#### **CERTIFICATE OF APPROPRIATENESS**

Property: 7735 Meadville Street, Lot 14, Block 54, Glenbrook Valley Neighborhood

Proposal: Alteration: Windows

ITEM B13 7735 Meadville St Glenbrook Valley

#### Photos Provided By Staff: 6-24-2025

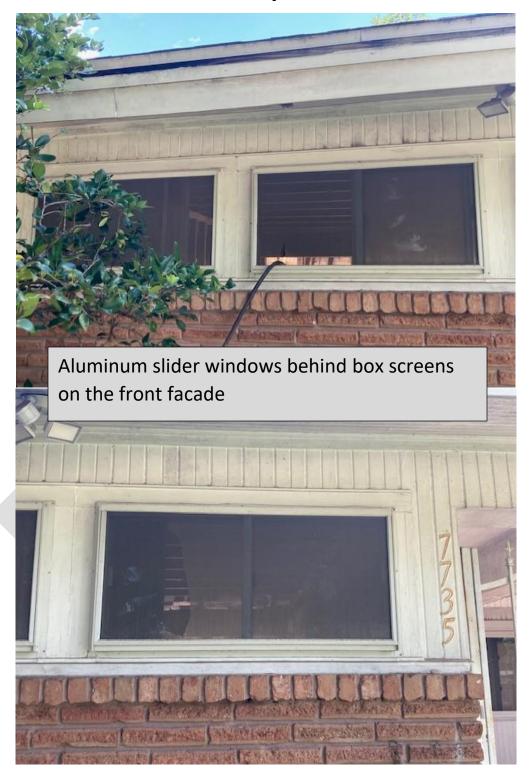
Aluminum slider windows behind box screens to the left of the front door

Aluminum slider windows behind box screens to the right of the front door
